DESIGN CHANGE REQUEST (DCR)

Model	Part Name / List	Drawing No.	Part No.
M-700	TRIGGER	C-15280	<u> </u>

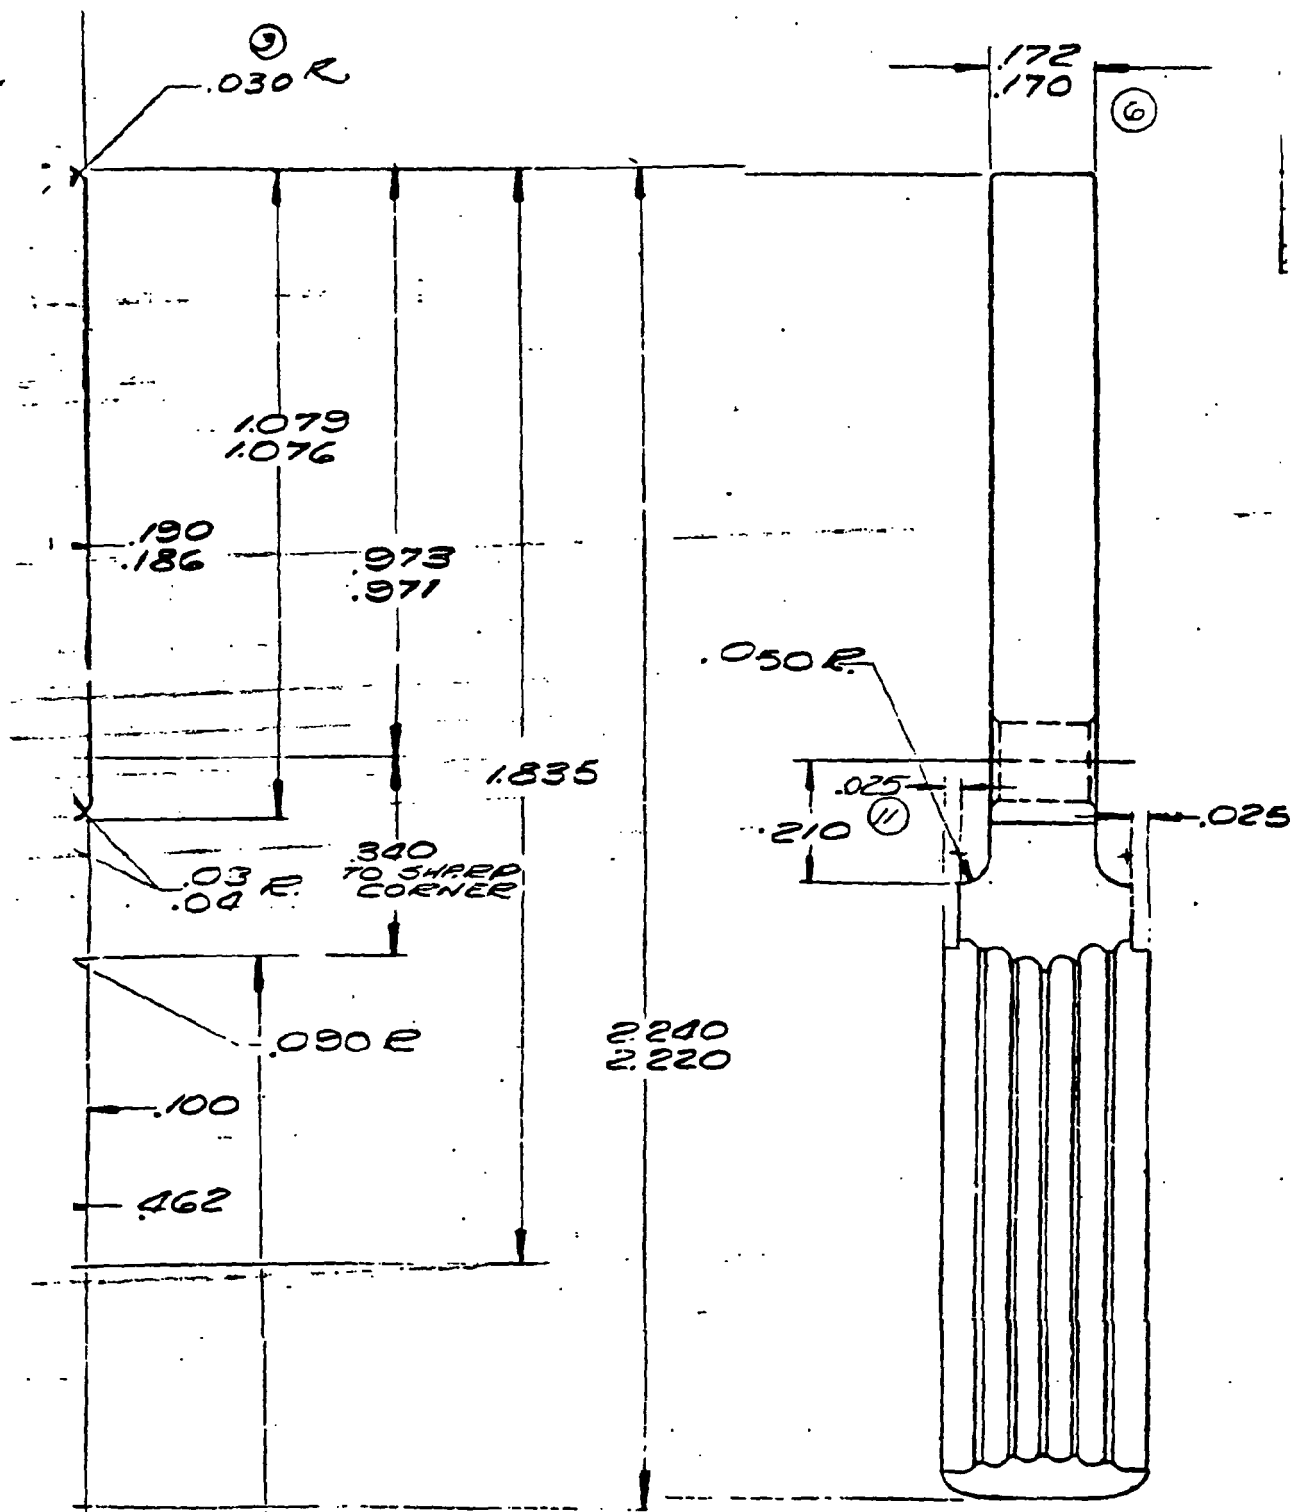
Dwg. No.	Rev. No.	Design Change
C-15280	14	ADDED SECTION B-B
	15	CHANGED MAT'L. WAS POWDER METAL
	16	ADDED 90° ± 00° 15
	17	ADDED NOTE

Reason for Change: TO IMPROVE THE FUNCTION OF THE TRIGGER
ASSEMBLY BY ELIMINATING INTER FEARANCE BETWEEN
TRIGGER AND HOUSING

NOTE:
HOLE TO BE DRILLED &
REAMED AFTER FABRICATION
